Urban Design Assessment Report

Planning Proposals for Milton Street Precinct No. 149-163 and 165-171 Milton Street, Ashbury

Date: 27 November 2017

Figure 22- 'Built Form massing'

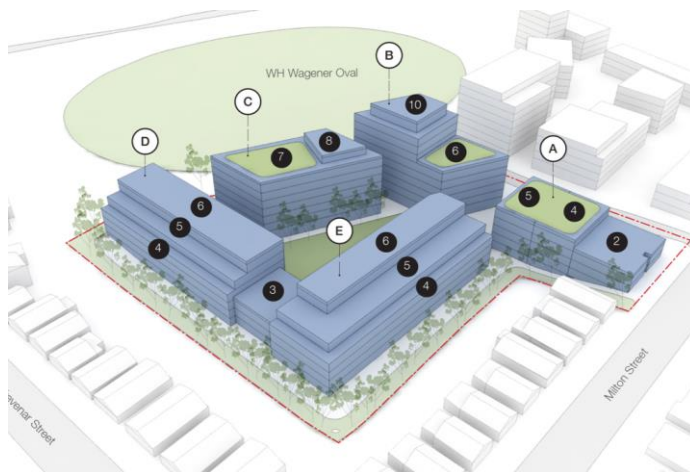
As per the Principles for Milton St discussed in Section 3.2 and discussions with Council, post the amalgamation, regarding the current schemes' scale and visible compatibility with the surrounding context, GMU prepared the following 'Recommended Concept Masterplan' to guide the applicants in arriving an appropriate built form for the two sites. The heights and access network recommended in this recommended concept masterplan have been amended based on sectional studies (Sections A-E) and newly received technical advice from Council's independent consultants. The sectional studies provide an analysis of the proposed building heights to understand at what heights the proposed developments protrude above the lines of sight, when viewed from Milton and Trevenar Streets. They also investigate the bulk and scale relationship between the appropriate built forms and the adjoining dwellings' backyards, to achieve a sensitive interface.

Figure 24- Milton St Frontage- no more than 2 storeys with single storey presentation

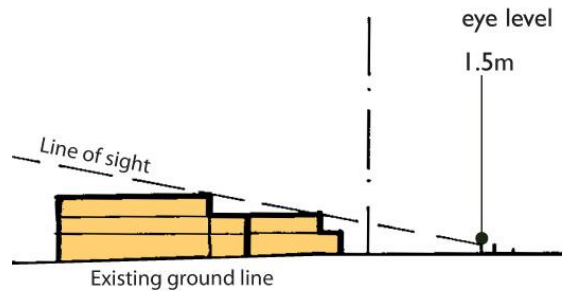
Milton St consists of predominantly single-storey dwellings. The proposed 2-3 storey and 2-5 storey built form proposed by both schemes is not supported, as it defers from the existing street scale and character of Milton St.

GMU considers a 2-storey building typology, with a single storey architectural feature (i.e. portico, porch or verandah) fronting Milton St, to be a more sympathetic built form.

Figure 25- Residential Interface adjacent to Yabsley Ave dwellings to be 3-storey building with a perceived height of 2 storeys and recessed top level away from line of sight

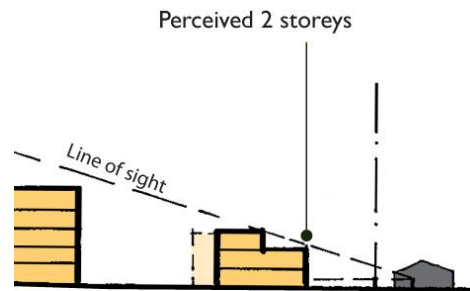
Section A is through the northern boundary of the northern site and the existing dwellings along Yabsley Avenue. It is recommended to have a built form of no more than 3 storeys and should only be perceived as 2 storeys from adjoining dwellings. The 3rd storey should be recessed away from line of sight.

Figure 26- Section from Milton St through the site to the Oval- Buildings to be kept under the line of sight from across Milton St

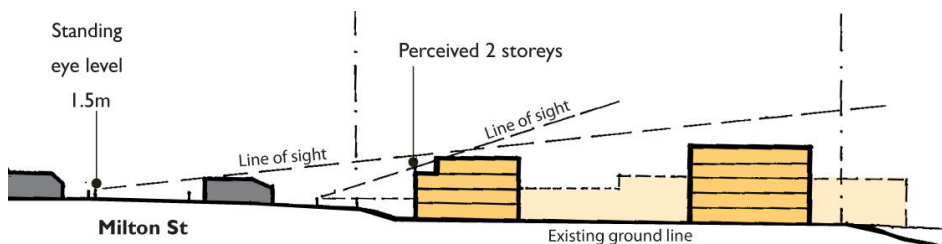
Section C is from east to west through Milton St and across the southern site. Due to the existing 4m level change from Milton St to the middle of the southern site, there is opportunity for an additional level from the existing ground line RL 36.5. The recommended built form for the eastern boundary of the southern site, at the rear of the dwellings along Milton St should be no more than 4 storeys with a perceived height of 2 storeys and the top level to be recessed away from line of sight.

Figure 27 - Residential interface at the SW corner of southern site (lowest point of the precinct)

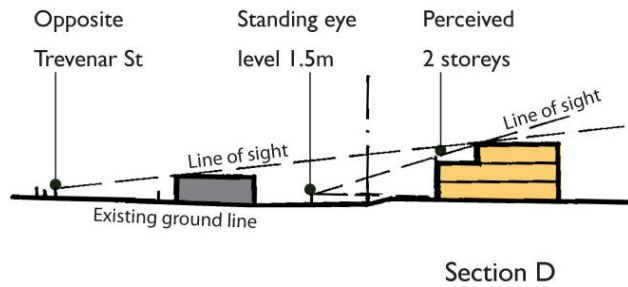
Section D is (south-west corner of the southern site and across Trevenar St) through the lowest point of the precinct. As the southern site sits slightly higher than the dwellings along Trevenar St, its built form will have more significant visual and privacy impacts onto the adjoining dwellings.

GMU recommends similar built form as Section A (perceived 2 storey building with the 3rd storey recessed away from sight) to respond to this edge condition.

Figure 28 - Residential Interface at the rear of Trevenar St dwellings

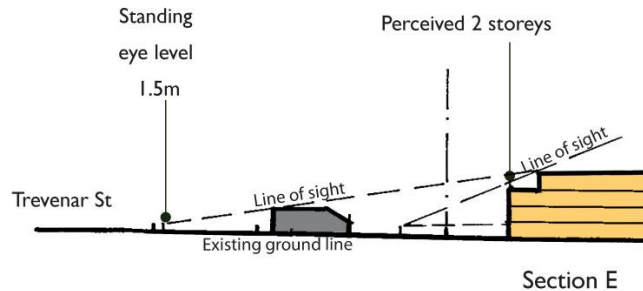
Section E is through Trevenar St and the south-eastern corner of the southern site.

For this eastern end of the southern boundary, a 4-storey built form with 2-2.5 storey perceived height is acceptable.

Figure 31: Access & Movement Diagram (Source: Urban Design Study by SJB Architects)

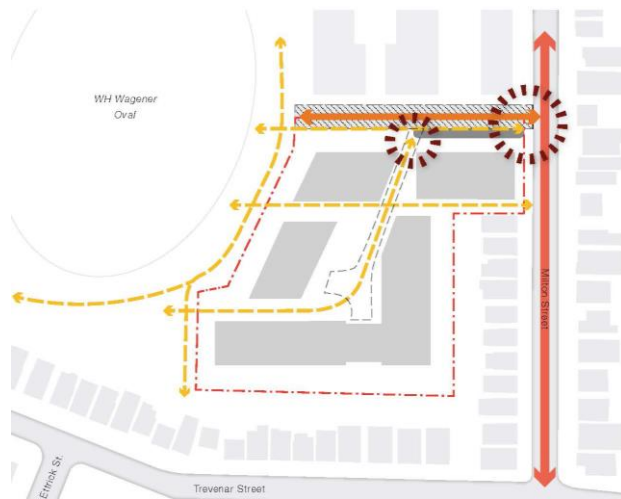
The current southern scheme has not proposed any internal road of the shared entry access road along the common boundary of the two sites. All future traffic will enter/exit the basement parking from this access road, however the number and location of basement car park entries off this access road are unclear. Due to the size of the site, the shared access road can only provide a limited number of basement car park entries. Waste collection for all the proposed buildings within the southern site will be difficult, especially with Council's limited distance of travel to waste collection points. The proposed single amalgamated car park will also result in future residents traversing long distances from their vehicles to their apartments. Similar to the northern site, GMU proposes a single-lane loop road with limited on-street parking that is connected to a number of basement parking entries encapsulated within proposed buildings.

2 pedestrian links are currently proposed (refer to Fig. 32), along the northern and southern facades of Buildings A & B, that directly connect Milton St to WH Wagener Oval. The location of these links is well considered as it directs the local community to the centre of the oval and could potentially open up district views to the east across the oval and Whitfield Avenue, providing a visual corridor from Milton St. The third pedestrian link connects the new access road to the Oval via the central communal open space. This linkage can be further extended into the northern site.

For both sites, the extent of all vehicular driveways should be minimised and parking entries should be encapsulated within buildings. Garbage collection should be carried out within the basement.

Figure 36- Section near the corner of Trevenar St and Milton St Figure 37- Western end of Trevenar St- at the precinct's lowest point

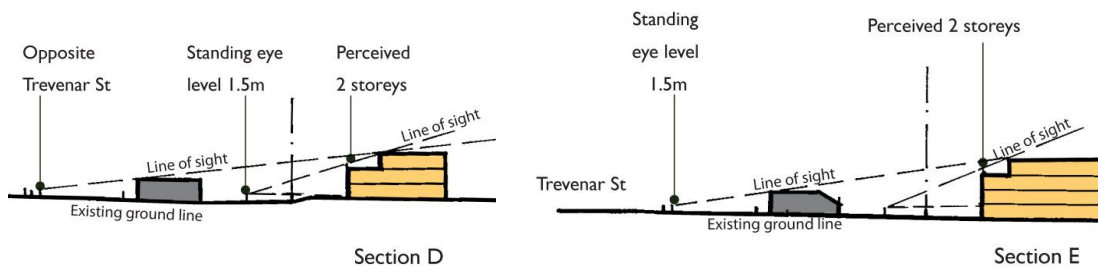
There is currently an insufficient level of detail to provide in-depth assessment on privacy. However, the taller forms along the rear gardens of the low scale dwellings along Yabsley Avenue, Milton and Trevenar Streets have their balconies facing directly to the adjoining properties, although they are setback at least 12m away from the common boundaries. Through sectional studies along the changing topography, GMU considers that these edge buildings especially Block 1 of the Northern Site, (Buildings D & E), are inappropriate to the residential interface and should be reduced to have perceived height of 2 storeys and no taller than 3-4 storeys high.

Additionally, the developments should demonstrate that redirection of outlooks can be provided to mitigate any potential overlooking to fully satisfy the objective of this DCP privacy control.
